## PIC16F88X Family Silicon Errata and Data Sheet Clarification

The PIC16F88X family devices that you have received conform functionally to the current Device Data Sheet (DS41291G), except for the anomalies described in this document.

The silicon issues discussed in the following pages are for silicon revisions with the Device and Revision IDs listed in [Table 1](#). The silicon issues are summarized in [Table 2](#).

**FIGURE 1: SCK PULSE VARIATION USING TIMER2/2**

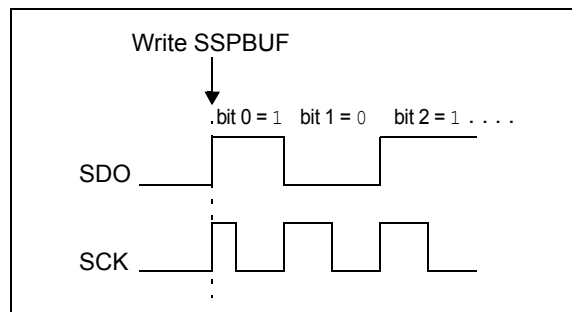
When the SPI is using Timer2/2 as the clock source, a shorter than expected SCK pulse may occur on the first bit of the transmitted/received data ([Figure 1](#)).

To avoid producing the short pulse, turn off Timer2 and clear the TMR2 register, load the SSPBUF with the data to transmit and then turn Timer2 back on. Refer to [Example 1](#) for sample code.

FIGURE 3: ACTUAL (INCORRECT) OPERATION WITH CLOCK STRETCHING – EXAMPLE 1

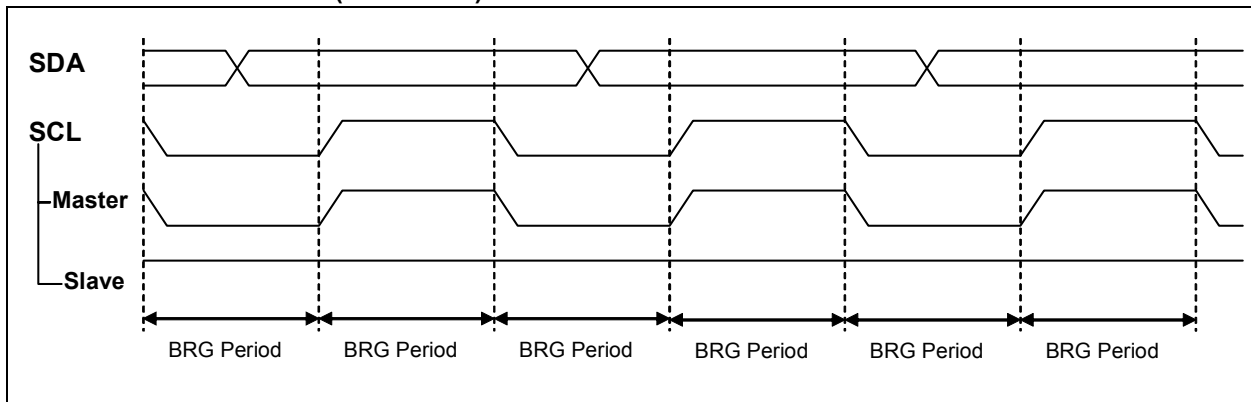
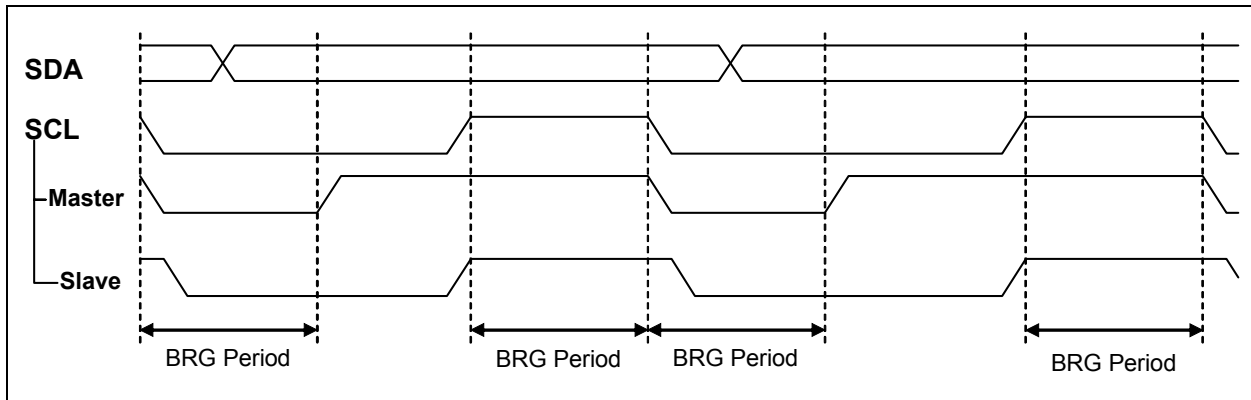
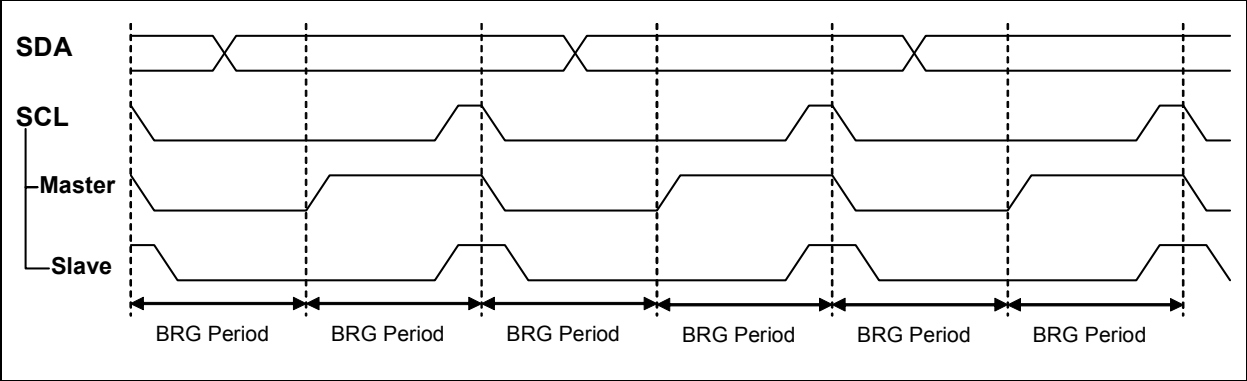
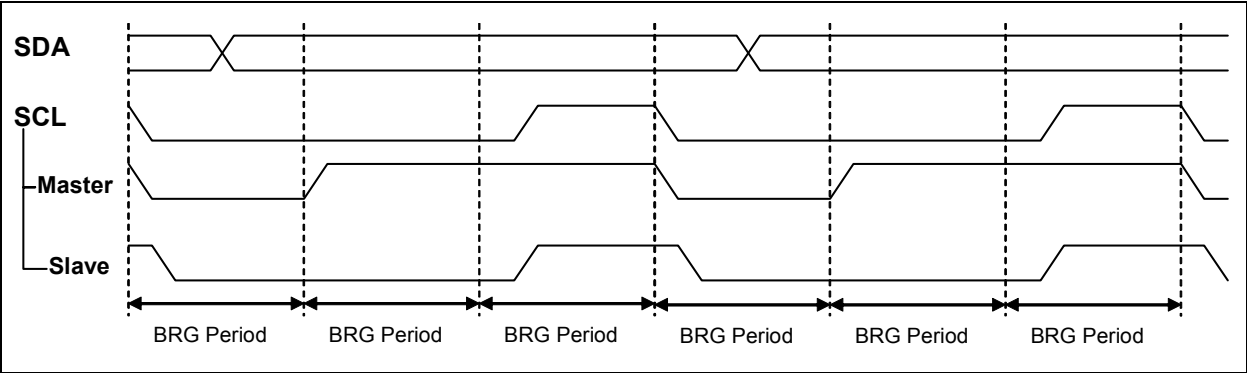
When the MSSP is I<sup>2</sup>C™ Master mode with a slave device stretching the clock, the clock generation does not function as described in the data sheet.

When a slave device is performing clock stretching by pulling the SCL line low, the master device should continuously sample the SCL line to determine when all slaves have released SCL. When SCL is released, the master device should wait one BRG period to ensure a constant SCL high time.

The current implementation does not ensure accurate SCL high time. During clock stretch, the MSSP device will erroneously continue running the BRG counter. At the end of the clock stretch the BRG counter continues to count down for the

remainder of the BRG period, and then the MSSP device will immediately resume transmitting the data.

Figure 1 illustrates an expected I<sup>2</sup>C transmission in which the SCL line is completely controlled by the master device and the slave device does not attempt to stretch the clock period.

Figure 2 illustrates the expected operation of an I<sup>2</sup>C transmission in which the slave device has stretched the clock period by holding the SCL line low. The high time of the SCL pulse is constant, regardless of the duration of the clock stretch.

Figure 3 and Figure 4 illustrate an actual I<sup>2</sup>C transmission in which the slave has stretched the clock period by holding the SCL line low. Note that the high time of the SCL signal has shortened from the expected time.

Set the communication speed to match the slowest device on the bus. This ensures that no slave device will perform clock stretching.

It is possible to dynamically adjust the communication speed to match the device being addressed by modifying the BRG register. However, the behavior of slower slave devices must be understood and speed adjustments made such that no slave performs clock stretching.
